1. The section of the bracket and the stiffener;

2. The section of the bracket;

BKT AT END (2-b)

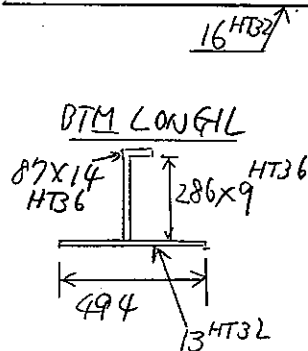
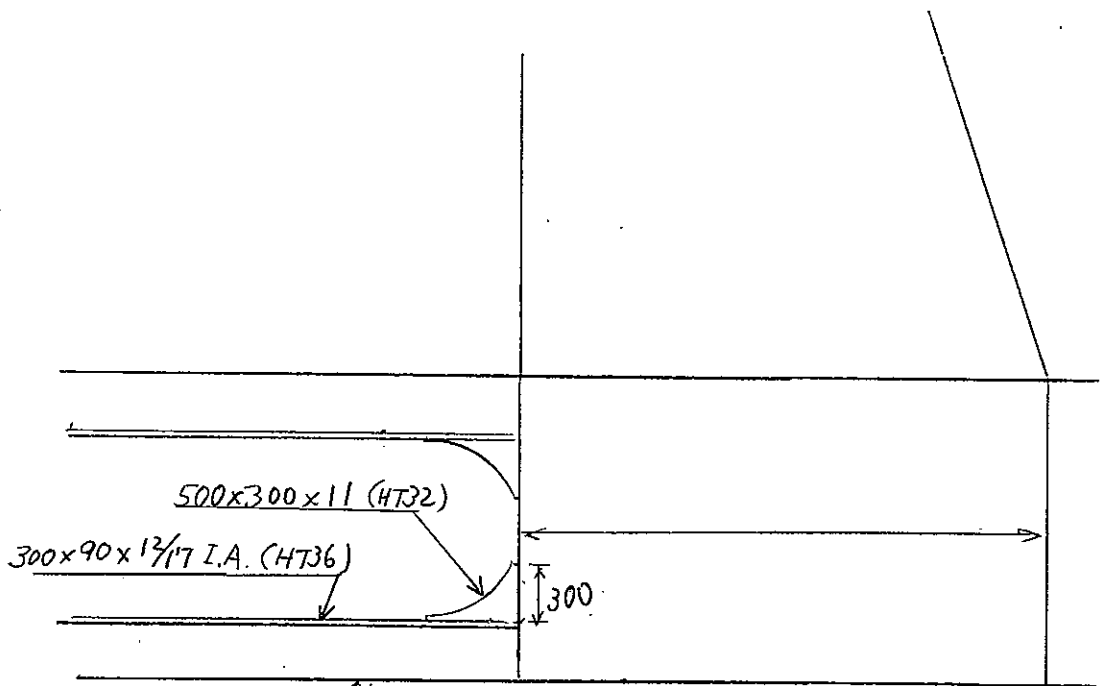
In case 1, is the snipped flange of the stiffener included in the calculations?

$(K = 0.78)$
 $SM = 795 \text{ cm}^3$
 (HT32)
 $SM' = 795 \times \frac{0.72}{0.78} = 733 \text{ cm}^3$

$A_{BKT} = 24 \text{ cm}^2$
 (HT32)

FOR HT36
 BASE,
 $t = \frac{37.92 \times 100}{300} \times \frac{0.78}{0.72}$
 $= 13.7 \rightarrow 14 \text{ mm}$

MODIFIED BKT AT END (2-b)

$A_{BKT} = 39 \text{ cm}^2$
 (HT32)

→ BRACKET SIZE TO BE INCREASED TO 300x16 HT32 FROM 300x11 HT32

→ IF MATERIAL FACTOR SHOULD BE CONSIDERED TO BE INCREASED TO 300x17 HT32
